2084 Brilla LLC

COMMENTS and RESPONSES 3/18/2024

Preliminary Subdivision and Land Development – 1st Review				1/12/2024
A. Zoning Ordinance Review				
1	1	<p>1. Sec. 232-380. – Use regulations.</p> <p>a. A variance was granted but not reflected in the Zoning Table and note 5 is incorrect. It reads: Auto Repair and Storage Garage, not what was granted. Update the note to reflect the accurate approved uses and identify that a variance was granted.</p> <p>i. Proposed use of a warehouse distribution (Lot 1)</p> <p>ii. Proposed personal storage garage (Lot 2).</p>	Note 5 has been replaced with revised tables.	1
2	2	<p>Sec. 232-583. – Yard exception for private garages, accessory building and retaining walls.</p> <p>a. The applicant proposes a 5-foot-tall board-on-board fence along Pine Ave for screening purposes.</p> <p>i. Fences located beyond the front setback line shall not exceed four (4) feet in height. Please revise the design.</p> <p>b. Retaining walls shall not be located any closer than three (3) feet from property lines unless construction and maintenance easements are produced from abutting property owners. Retaining wall #3 has a section that is perpendicular to parcel 02-

SHEET 2 OF 20

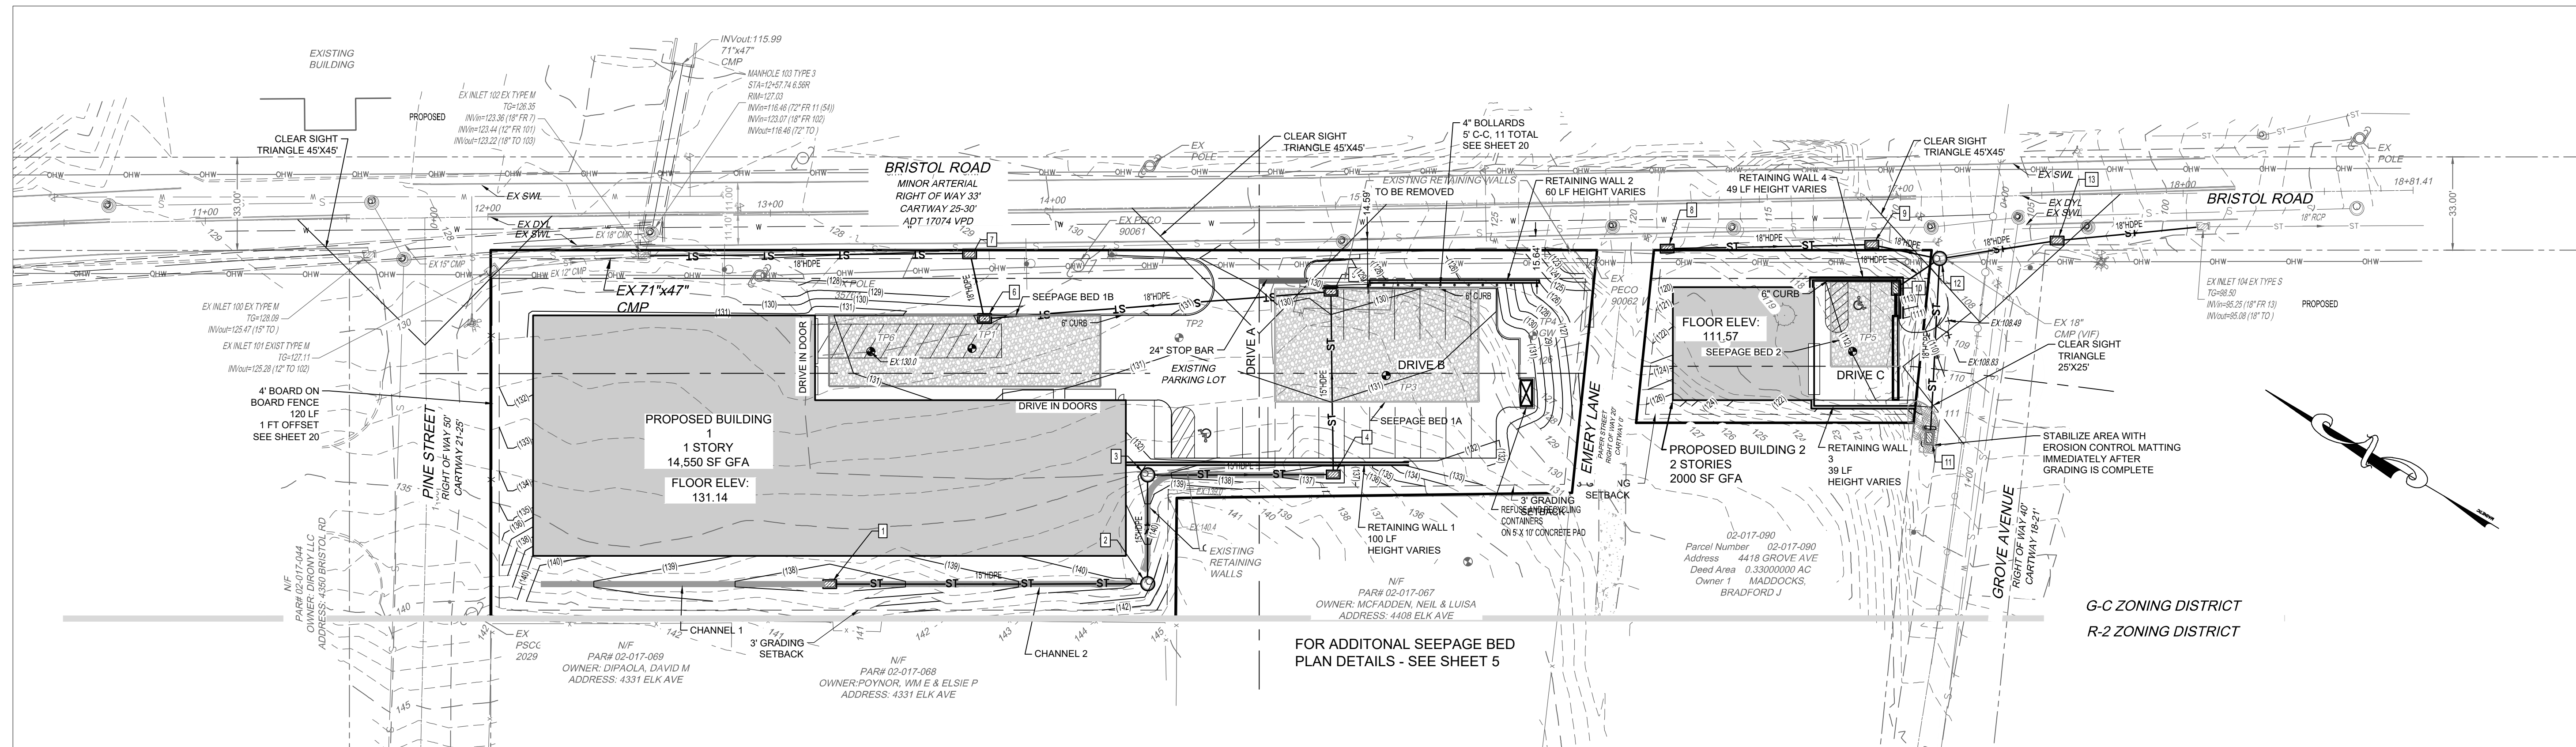
B. Subdivision and Land Development Ordinance (SALDO) Review				
3	1	<p>1. Sec. 201-41. – Preliminary plan requirements.</p> <p>a. Please update the plans indicating that Emery Lane is a paper street.</p> <p>b. There is an overhead PECO utility line running along the frontage of Bristol Road. Confirm the presence of any easements on this land and provide a statement from the utility.</p> <p>c. The storm drain labels for the points of connection are incomplete. The information for these locations should be revised to provide all information.</p>	<p>Emery Lane label has been revised</p> <p>PECO has been contacted.</p> <p>All available storm drain information has been included on the plans.</p>	<p>1</p> <p>2</p> <p>5,14</p>

SHEET
3 OF 20

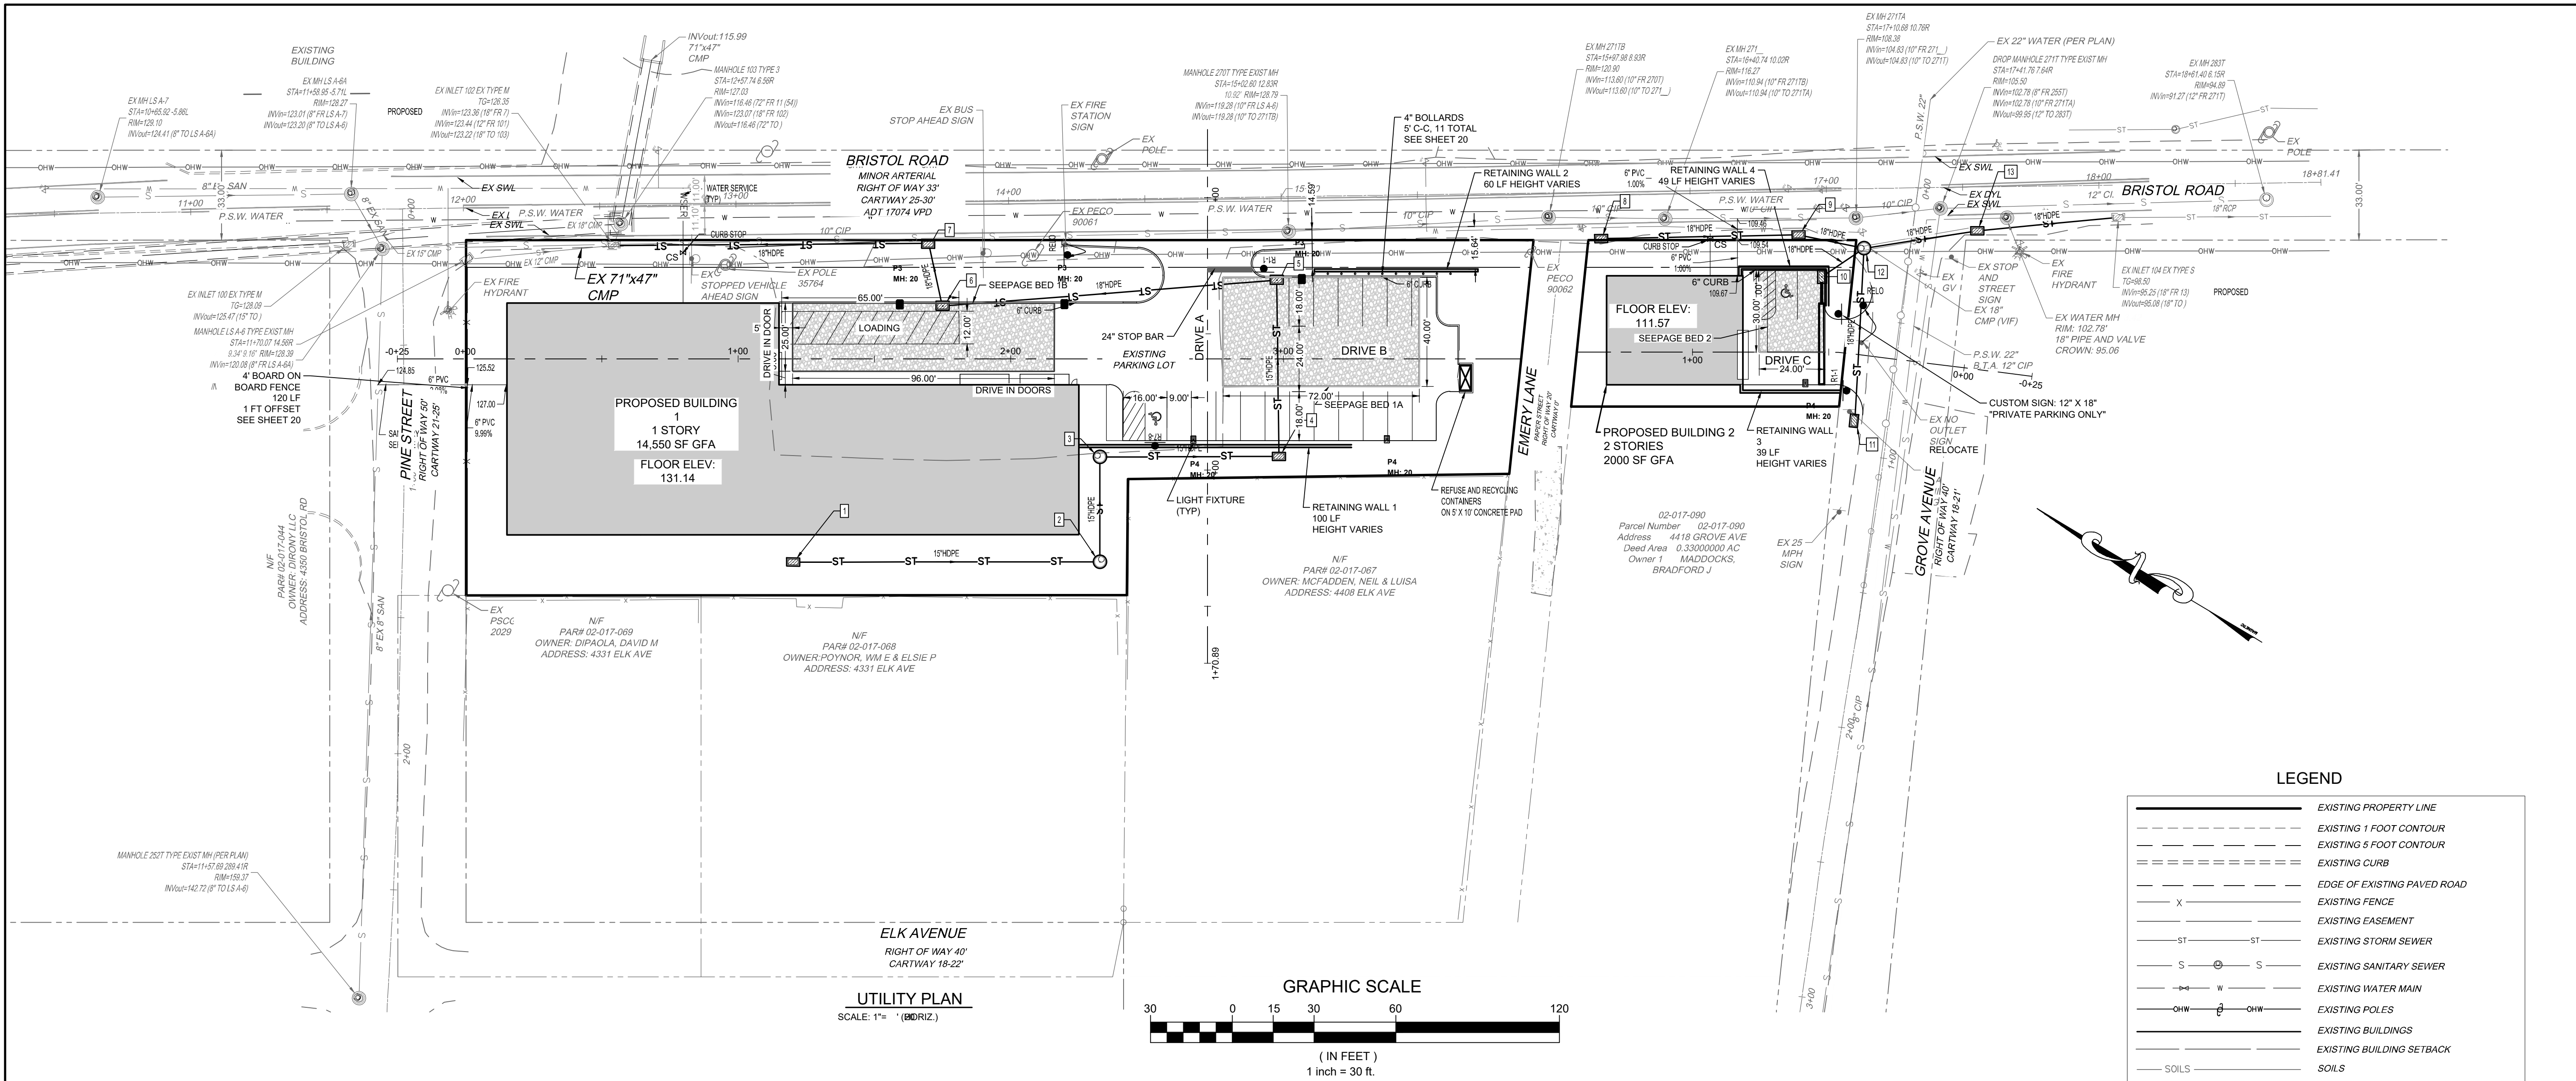
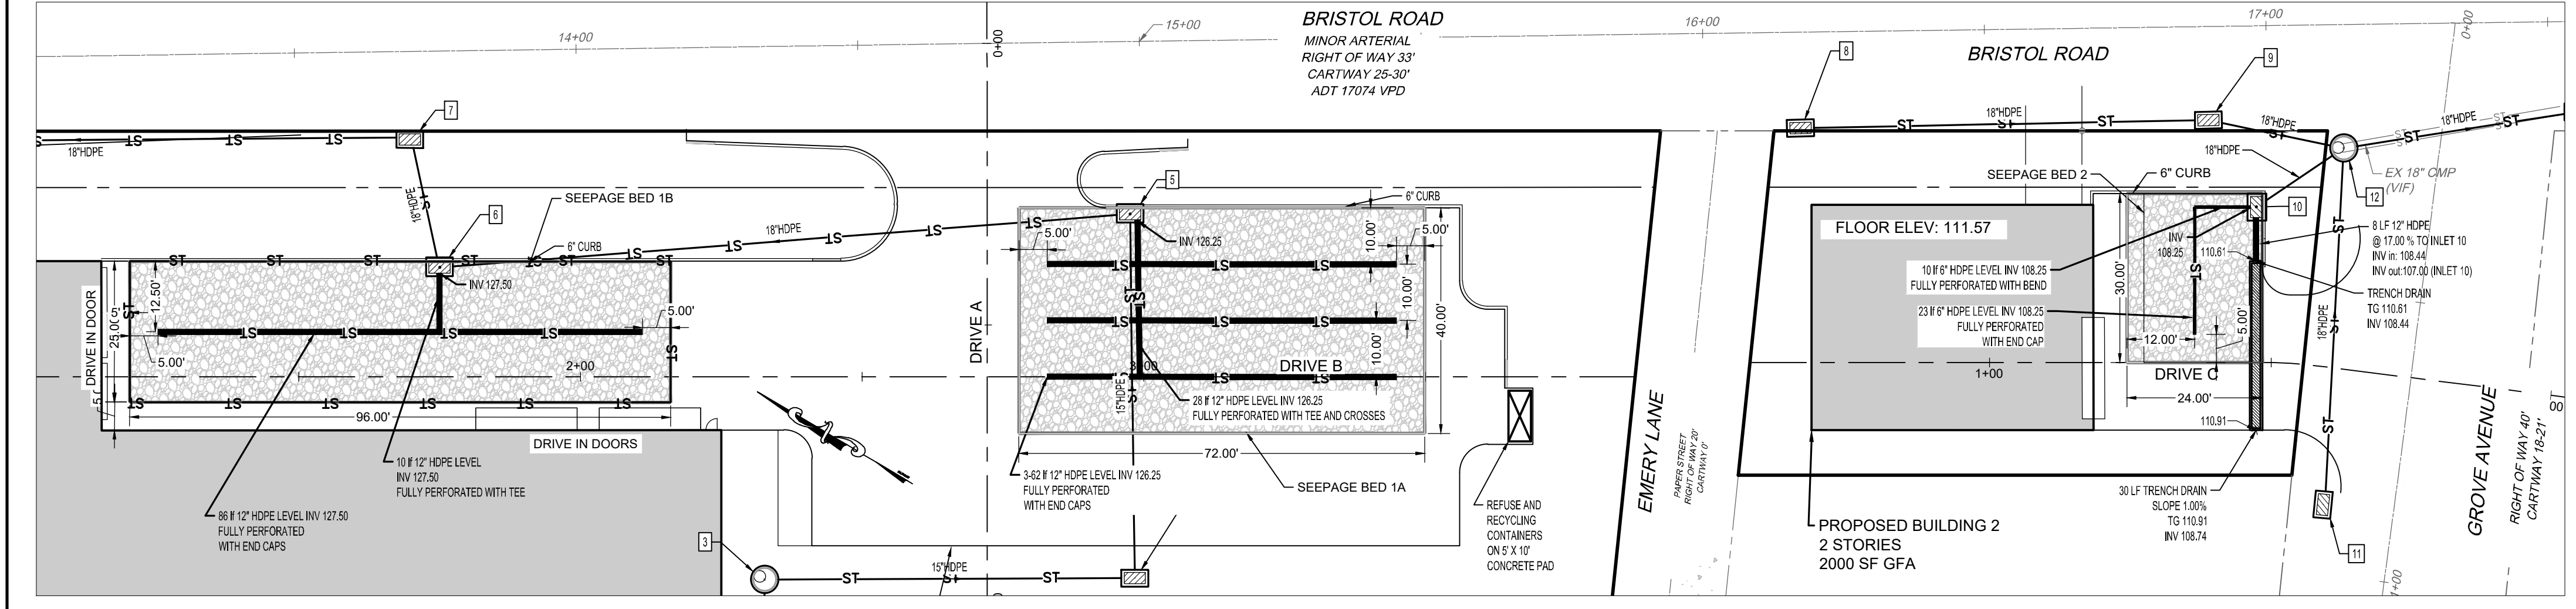
17	4	<p>The sight distance should be calculated for the driveway based on the appropriate grades and speeds using PennDOT’s sight distance formula. The following sight distance note should be provided for the driveway.</p> <p>“All sight distance obstructions (including but not limited to embankments and vegetation) shall be removed by the applicant to provide a minimum of xxx’ feet of sight distance to the left and xxx’ feet of sight distance to the right for a driver exiting the proposed driveway onto Road. The driveway must be considered to be positioned 10’ from the near edge of the closest highway through travel lane at an eye height of three feet-six inches (3’-6”) above the pavement surface. The point sighted by the exiting driver shall be three feet-six inches (3’-6”) above the pavement surface located in the center of the closest highway travel lane designated for use by approaching traffic. This sight distance shall be maintained by the applicant and/or the applicant’s successors and assigns”. Sight distance triangles indicating the heretofore-described sight distance should be shown to ensure that the existing/proposed landscaping will not restrict sight distance.</p>	Added Note 1	3

- ALL SIGHT DISTANCE OBSTRUCTIONS (INCLUDING BUT NOT LIMITED TO EMBANKMENTS AND VEGETATION) SHALL BE REMOVED BY THE APPLICANT TO PROVIDE A MINIMUM OF 440' FEET OF SIGHT DISTANCE TO THE LEFT AND 350' FEET OF SIGHT DISTANCE TO THE RIGHT FOR A DRIVER EXITING THE PROPOSED DRIVEWAY ONTO ROAD. THE DRIVEWAY MUST BE CONSIDERED TO BE POSITIONED 10' FROM THE NEAR EDGE OF THE CLOSEST HIGHWAY THROUGH TRAVEL LANE AT AN EYE HEIGHT OF THREE FEET SIX INCHES (3'-6") ABOVE THE PAVEMENT SURFACE. THE POINT SIGHTED BY THE EXITING DRIVER SHALL BE THREE FEET SIX INCHES (3'-6") ABOVE THE PAVEMENT SURFACE LOCATED IN THE CENTER OF THE CLOSEST HIGHWAY TRAVEL LANE DESIGNATED FOR USE BY APPROACHING TRAFFIC. THIS SIGHT DISTANCE SHALL BE MAINTAINED BY THE APPLICANT AND/OR THE APPLICANT'S SUCCESSORS AND ASSIGNORS.

SHEET 5 OF 20

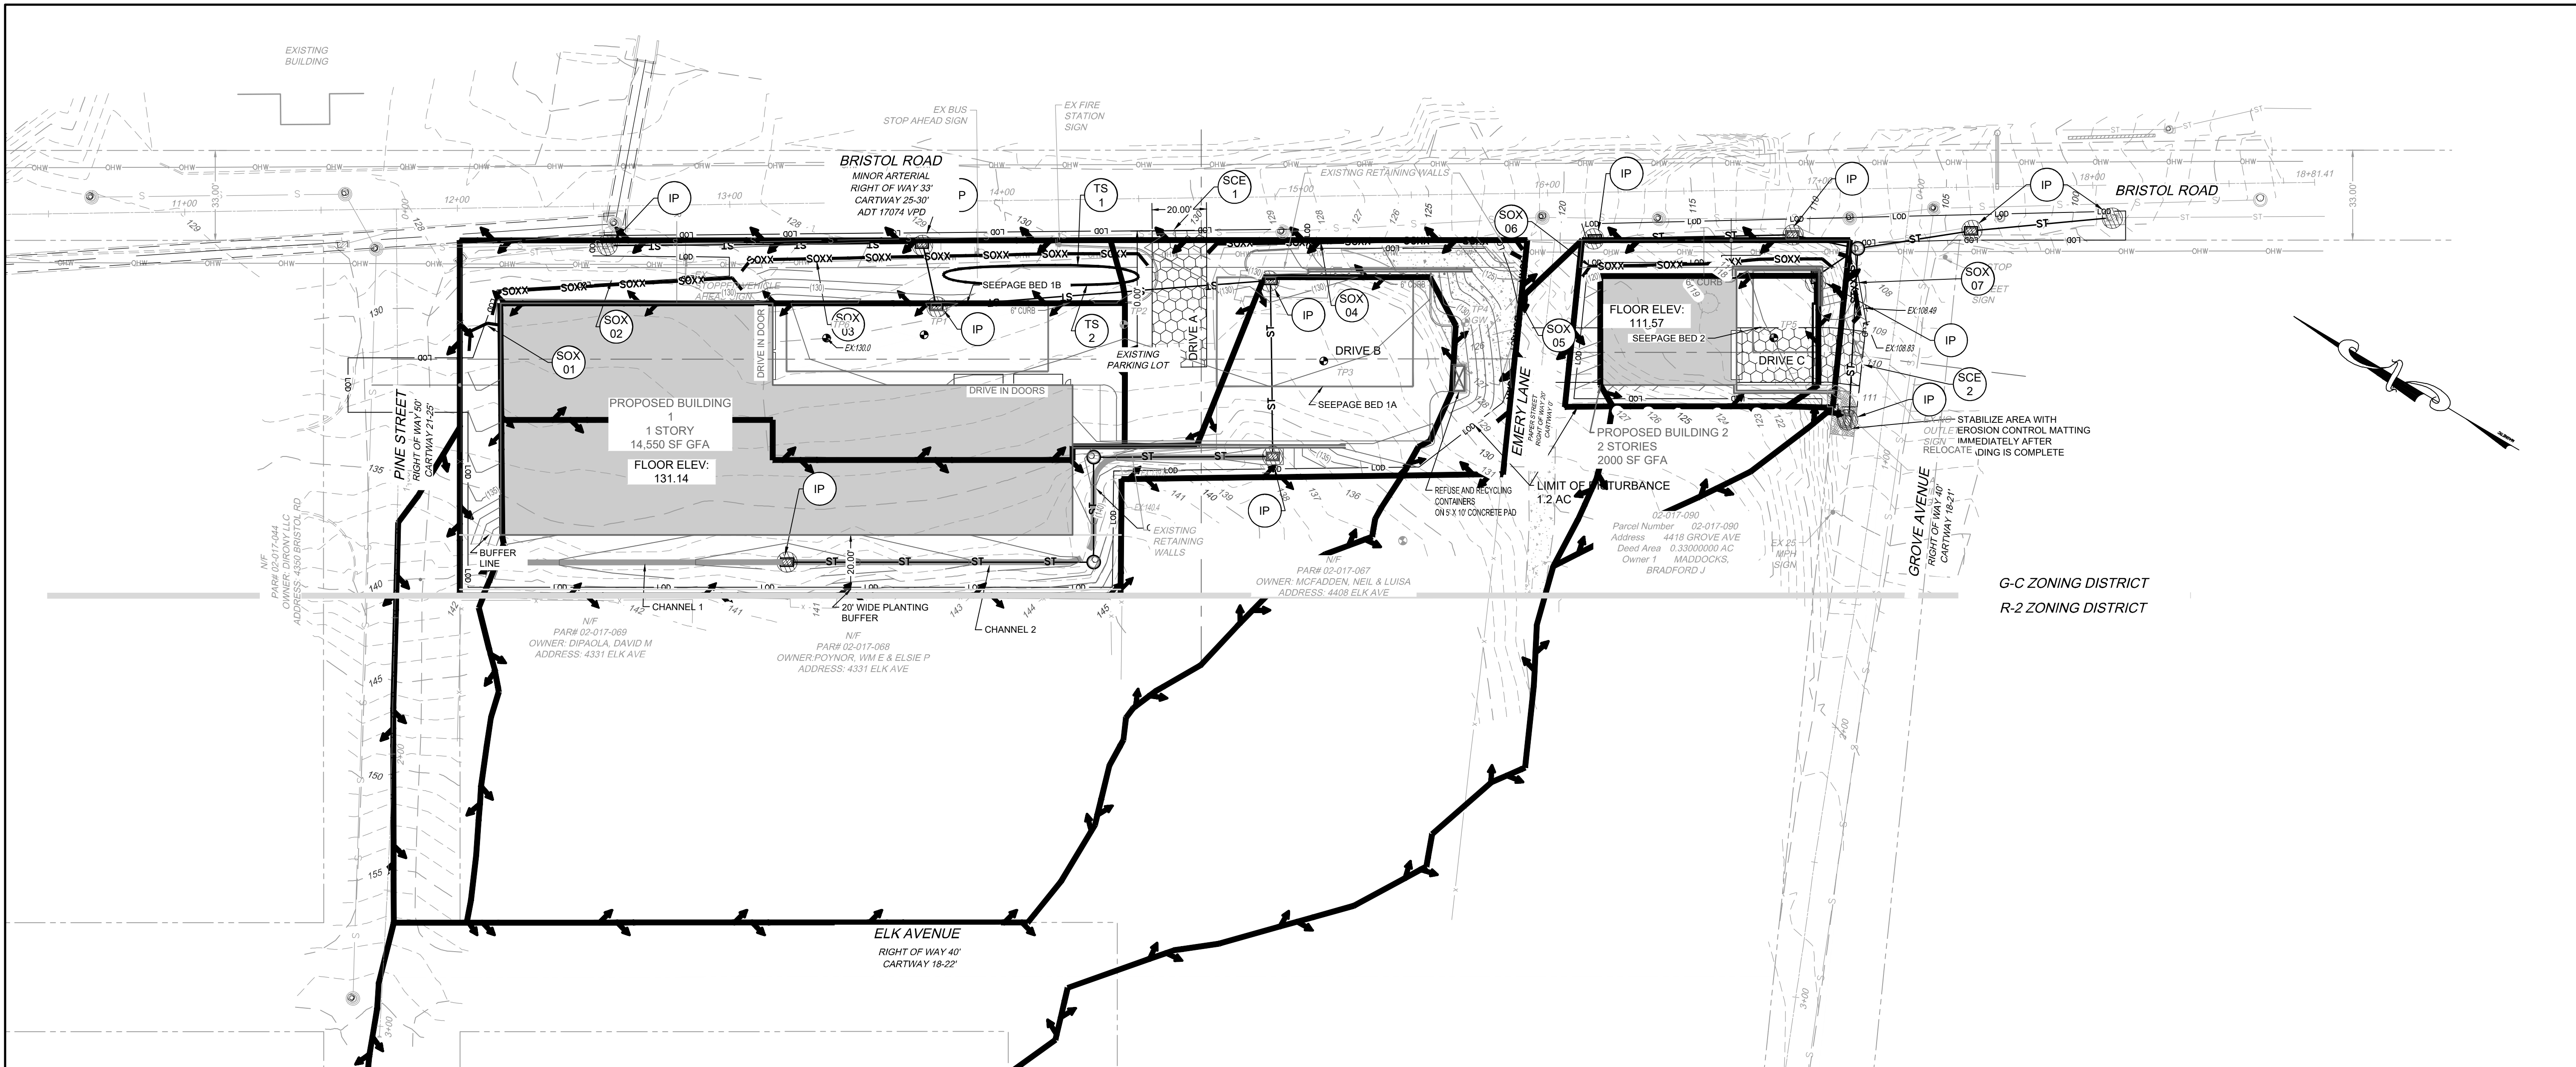
18	5	<p>The following general notes should be included on the plan:</p> <ul style="list-style-type: none"> a. “All proposed pedestrian facilities reflected on these plans shall be constructed to comply with the following standards: <ul style="list-style-type: none"> i. PennDOT Design Manual 2, Chapter 6. ii. PennDOT Standards for Roadway Construction, Publication 72M, RC-67M. iii. U.S. Access Board, Public Right of Way Accessibility Guidelines (PROWAG) and 2010 ADA Standards for Accessible Design.” 	Added Note 2	3
19	6	<p>Provide truck turning templates for the largest Township emergency vehicle. Note, the fire truck template used needs to be revised to the Township’s largest emergency vehicle.</p>	A larger truck has been used.	6
20	7	<p>Revise the retaining wall detail to show the correct grading behind the wall, bollards and parking lot location. Note, a full review of the wall calculations will need to be completed by our office.</p>	A second detail has been added for the wall with parking above. Structural design is in process with Joe Keil P.E.	5
